Solicitation No. 140FGA26Q0050
Vehicle Bay Insulation Project
Amendment 1, Q&A

ROOF FRAMING/BRACING PLAN

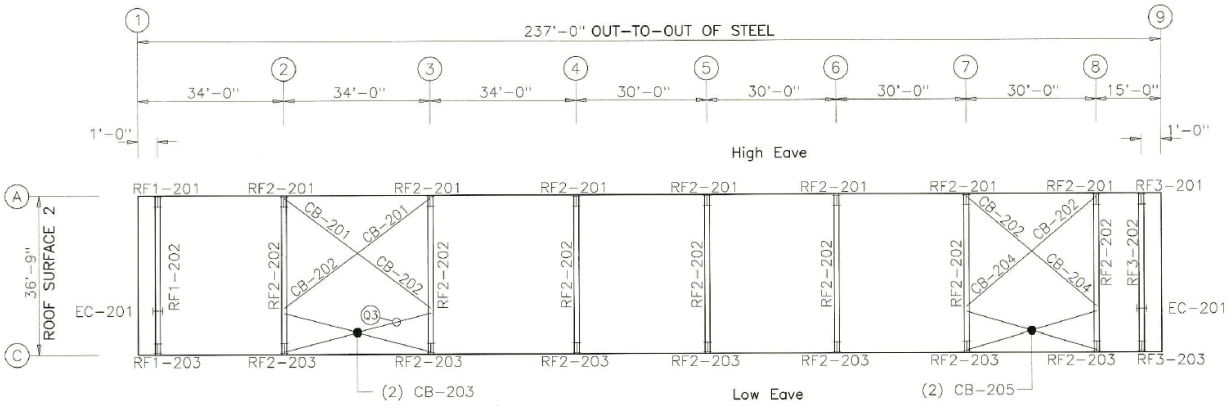
3. Please provide any available drawings, current photographs, floor plans, elevations, or measured net wall and roof areas for the building.

Answer: Refer to following pages 4-10 for what we have available.
